PGEN COMMENTS ON EPA'S PROPOSED RULE: NESHAP COAL- AND OIL- FIRED ELECTRIC UTILITY STEAM GENERATING UNITS REVIEW OF THE RESIDUAL RISK AND TECHNOLOGY REVIEW

Docket ID No. EPA-HQ-OAR-2018-0794

Figure 6-9. Sorbent Hg Removal in ESP in Lignite-Fired Unit: Effect of Injection Location

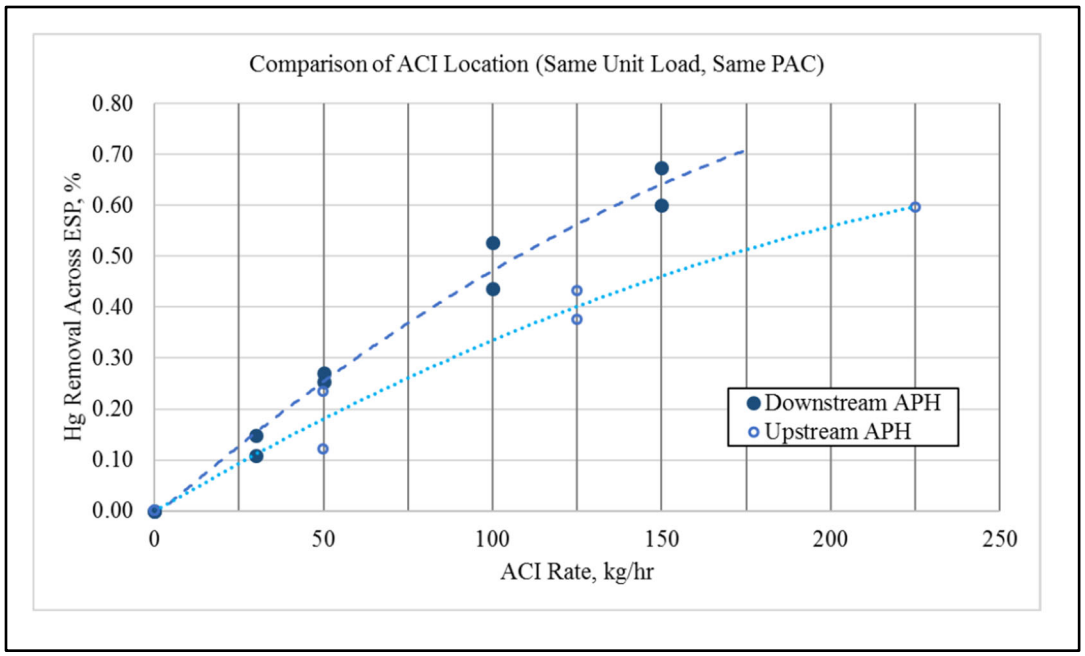
Publicly available field test data demonstrate the role of SO_3 on carbon sorbent effectiveness. Figure 6-9 presents results from a lignite-fired plant describing Hg removal across the ESP with sorbent injection.[35] This 900 MW unit is reported to fire a higher sulfur lignite in which more than 20 ppm of SO_3 in flue gas is observed preceding the air heater, subsequently decreasing to 10 ppm SO_3 existing the air heater.

Data in Figure 6-9 show the role of SO_3 in compromising sorbent performance - highest Hg removal is attained with lower SO_3 (downstream APH) with 60-68% Hg removal achieved (at an injection rate corresponding to 0.6 lbs/MACF).

Attaining a total system 92% Hg removal – the target as described by EPA – is likely not achievable given the trajectory of the curves as shown in Figure 6-9.

Figure 7-1. Mean, Standard Deviation of Annual Hg Emissions: 2018

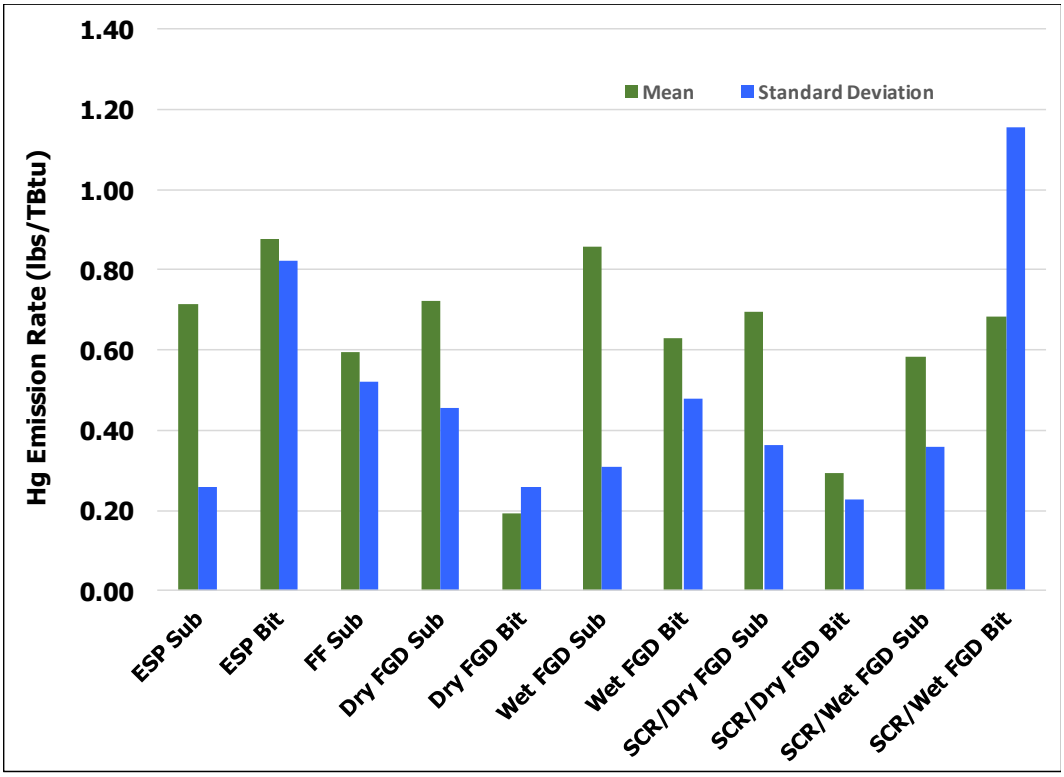
Figures 7-1 and 7-2 report two metrics of Hg emission rate variability.[38] Figure 7-1 presents the mean and standard deviation of Hg annual average emissions for eleven categories of control technology and fuel rank. For six of these eleven categories, the sum of the mean and the standard deviation approach the Hg limit of 1.2 lbs/TBtu.

Figure 7-2. Mean, Standard Deviation of Annual Hg Emissions: 2018

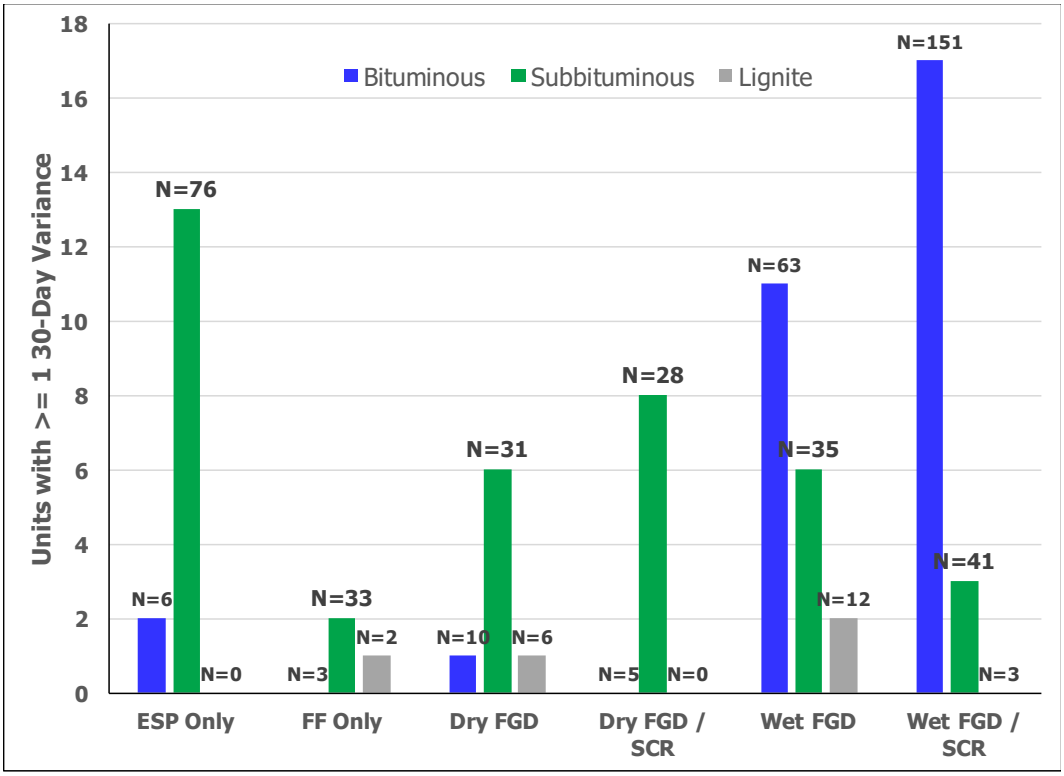
Figure 7-2 describes for six categories of control technology and 2 or 3 fuel ranks (depending on the technology) the number of units that for at least one operating day exceed 1.2 lbs/TBtu on a 30-day rolling average. Figure 7-2 shows for all categories of control technology and fuel rank experience 10% to 20% of units exceed this 30-day average.

Figure 7-3. Annual Average of Fuel Hg, Sulfur Content in Coal

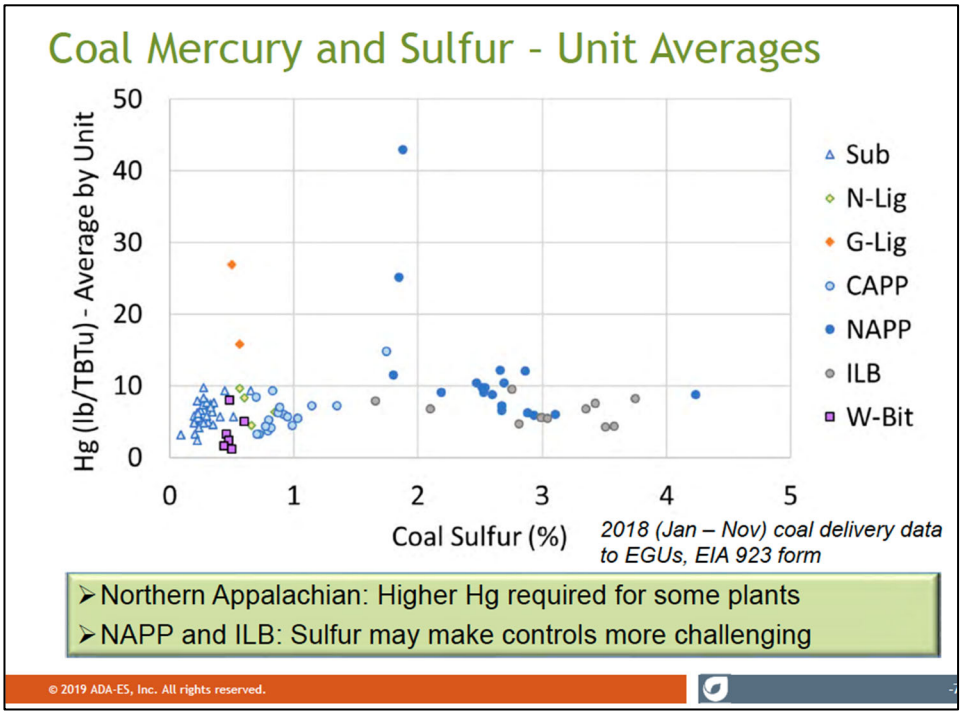
Figure 7-3 shows an average value of 5.5 lbs/TBtu does not represent either coal rank well. Figure 7-3 presents – on an annual average basis – data from more than 70 units reporting Hg content to the EIA. Numerous units report up to 10 lbs/TBtu - almost twice the average value EPA assigns, with 10 additional units reporting Hg content exceeding 10 lbs/TBtu. Northern Appalachian bituminous coals appear to contain higher Hg content than coals from other regions.

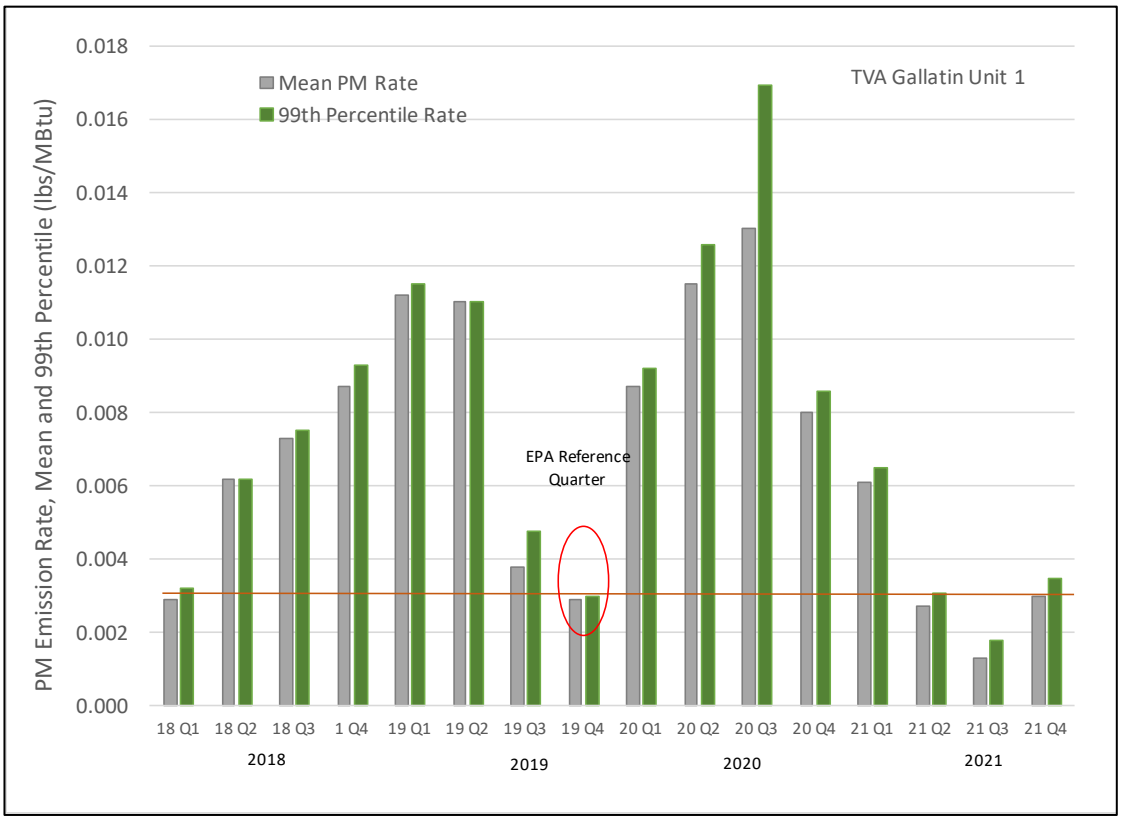
- TVA Gallatin Unit 4. EPA selected 0.0022 lbs/MBtu as the reference PM rate, using Q1 of 2021. Of the 14 quarters reporting data, two quarters report PM rates equal to this rate, while two are below this rate.

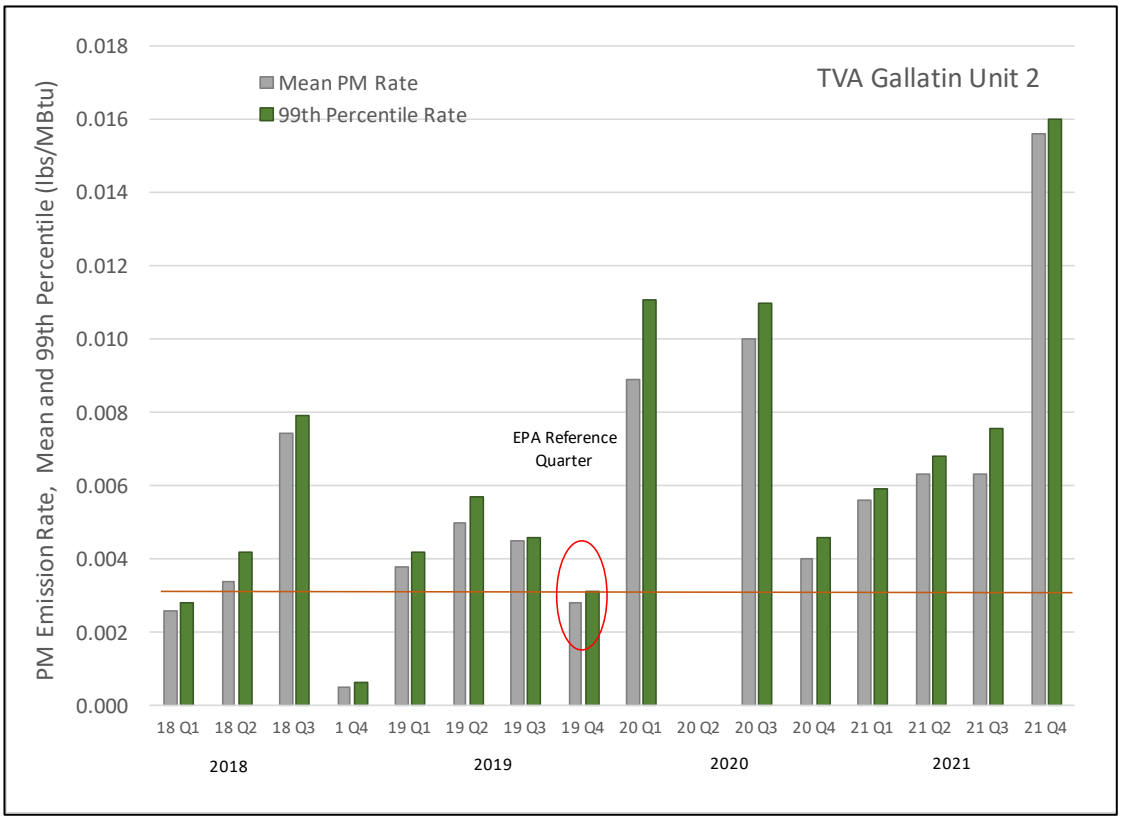
- LG&E/KU Ghent 1. EPA selected 0.005 lbs/MBtu as the reference PM rate, using Q2 of 2019. This PM rate represents that reported in previous quarters, but with one exception all subsequent quarters through 2021 report higher PM.

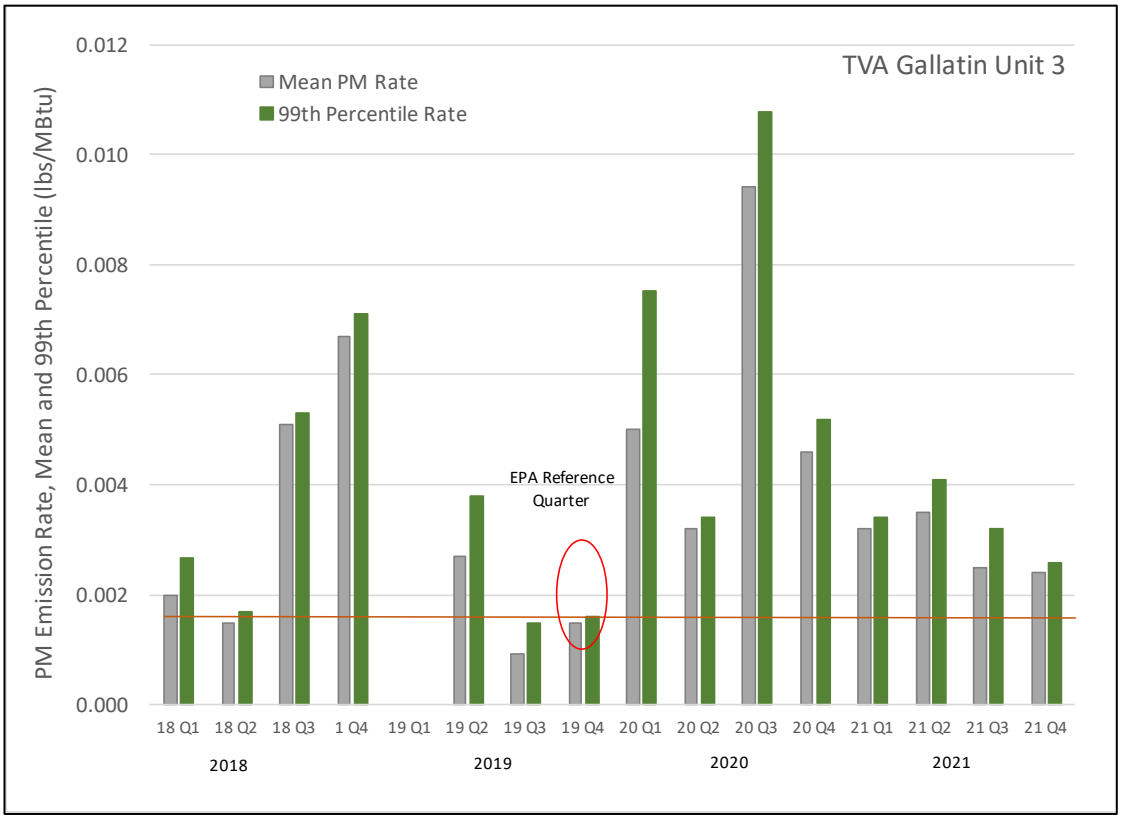
- Alabama Power Gaston Unit 5. EPA selected 0.005 lbs/MBtu as the reference PM rate, using Q1 of 2021. Data for this unit is displayed from Q1 2017 through Q4 2022. Of the 24 reporting quarters (1Q 2017 through 4QW 2022) only 6 quarters have lower PM rates.

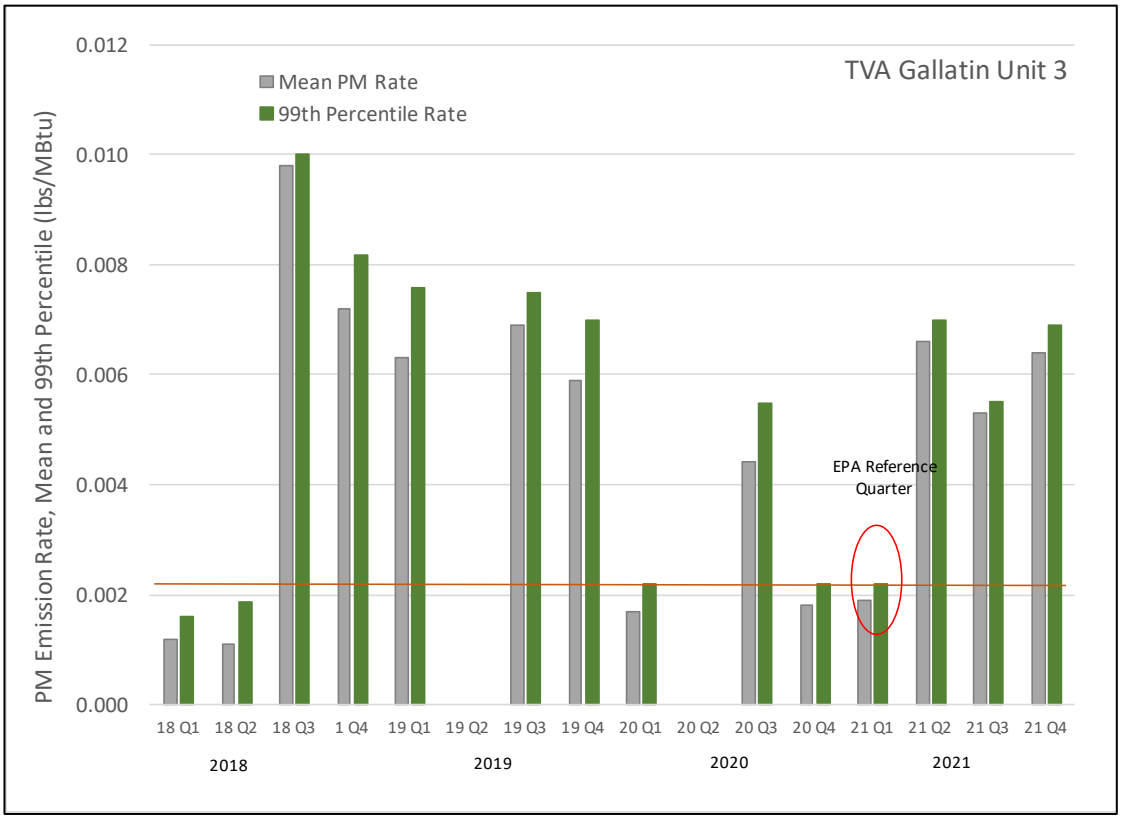
- Alabama Power Miller Unit 1. EPA selected 0.004 lbs/MBtu as the reference PM rate, using Q3 of 2017. Data for this unit is displayed from Q1 2017 through Q4 2022. The designated rate represents a significant reduction from approximately half of the reporting quarters since Q1 2020.
